# **Pearl Place Buildings I & 2**

**ADDENDUM II**

**September 22, 2006**

**Pearl Place**  
**Buildings 1 & 2**  
Portland, Maine

**C-2**

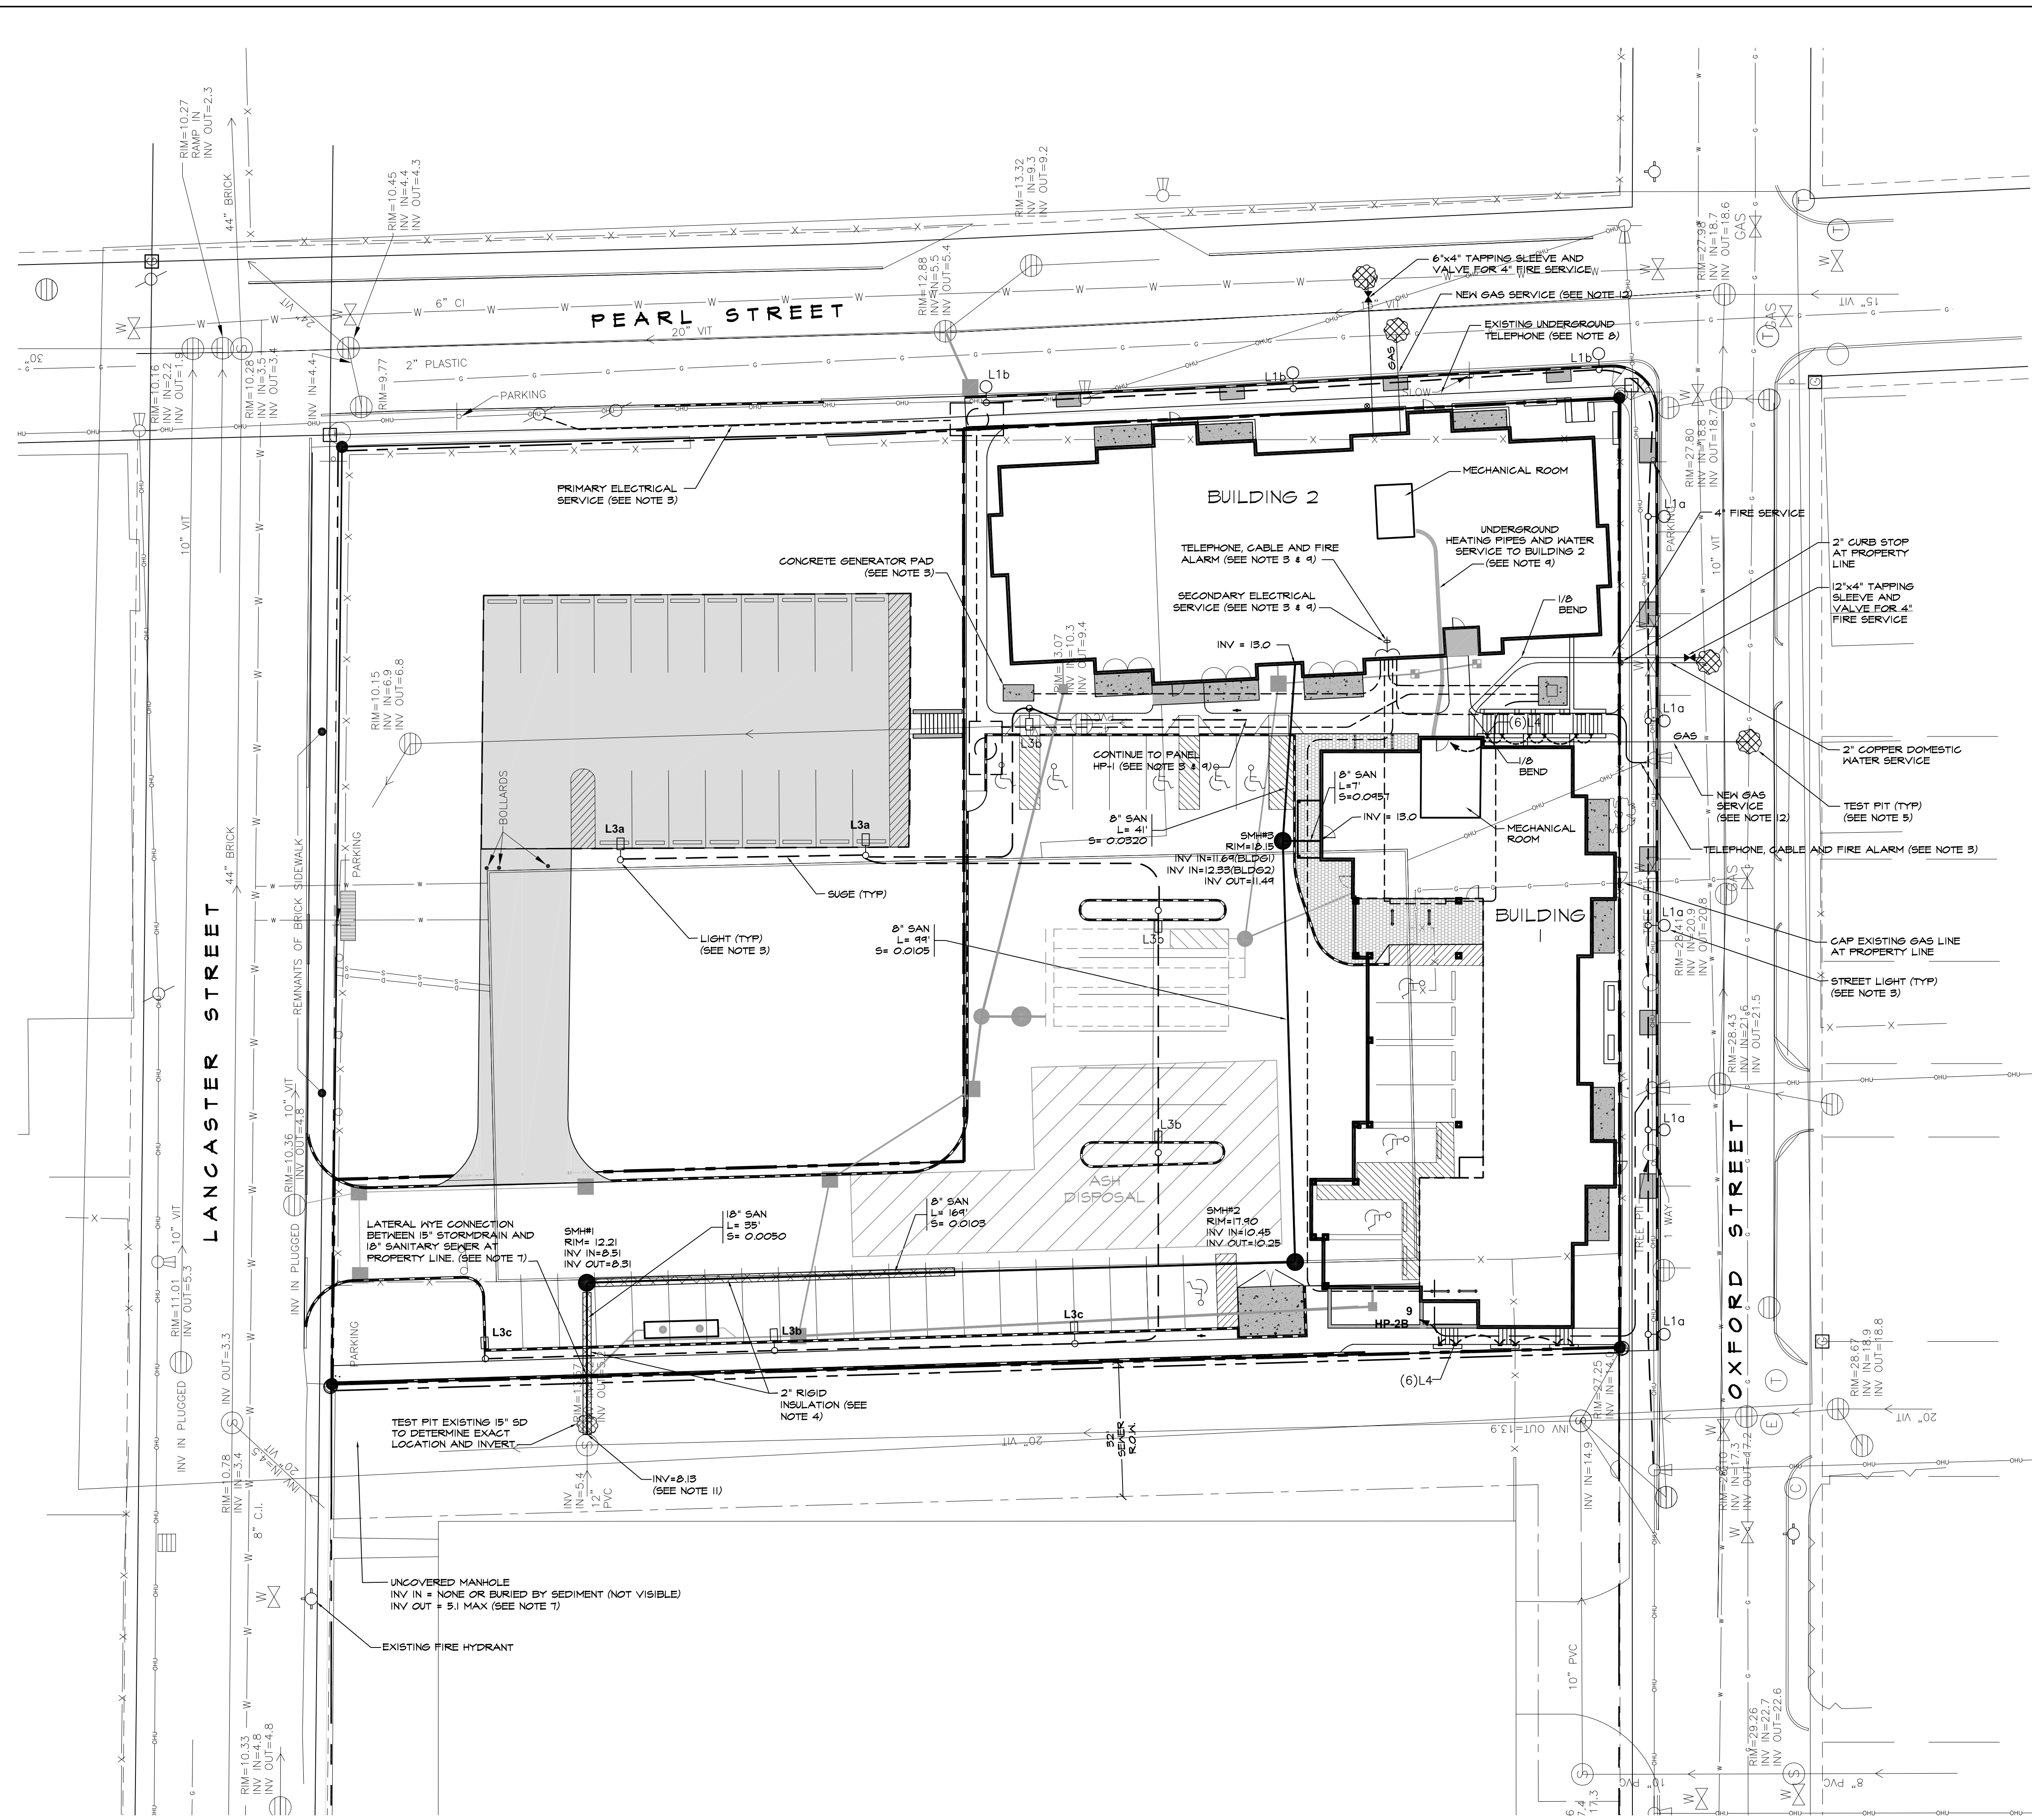
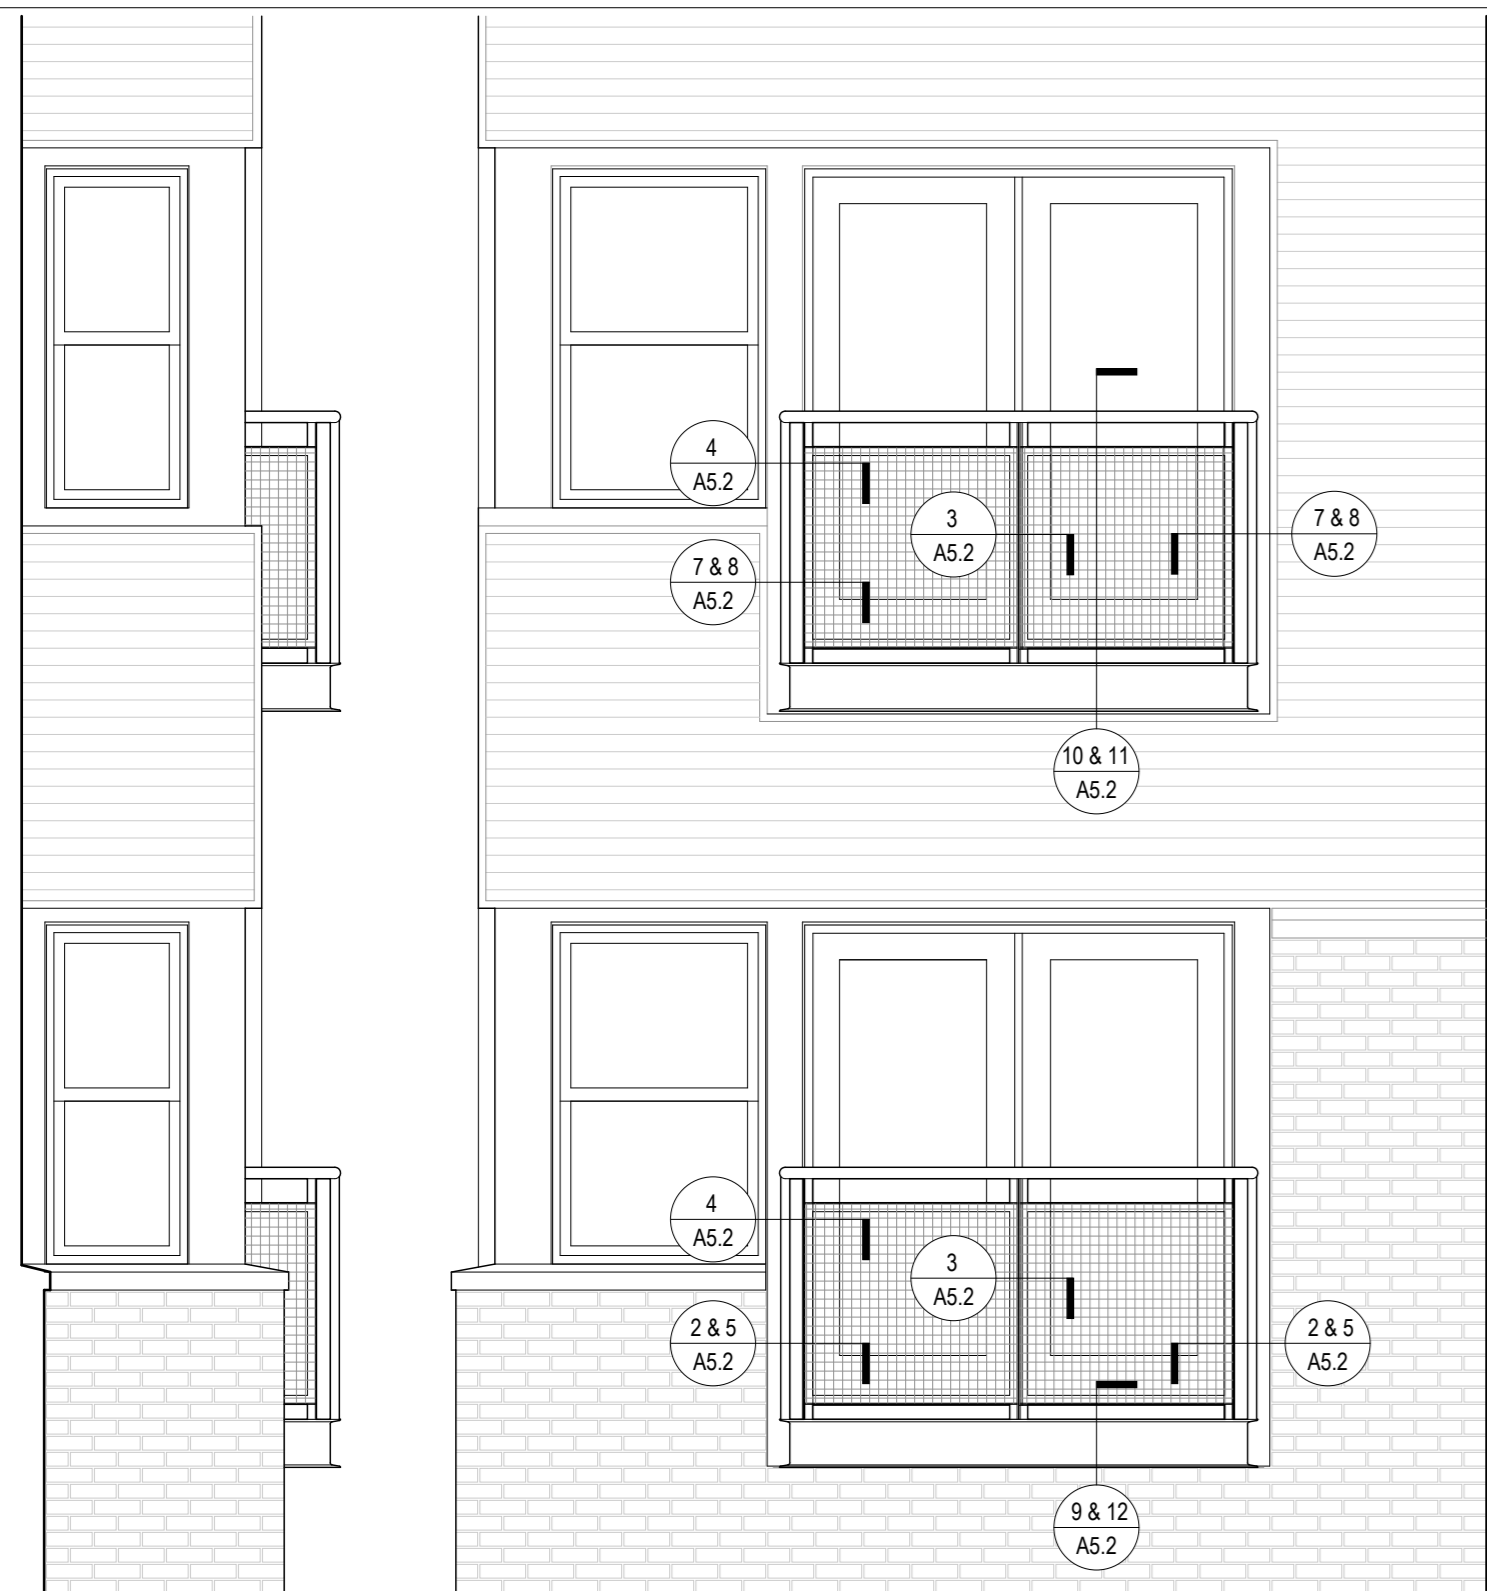
Q: Which is the right entrance for electrical service Oxford St (C-2) or Pearl St. (E0.1)

A: For Electrical Site work follow E0.1. Delete Oxford St. entrance from Oxford St. shown on C-2.
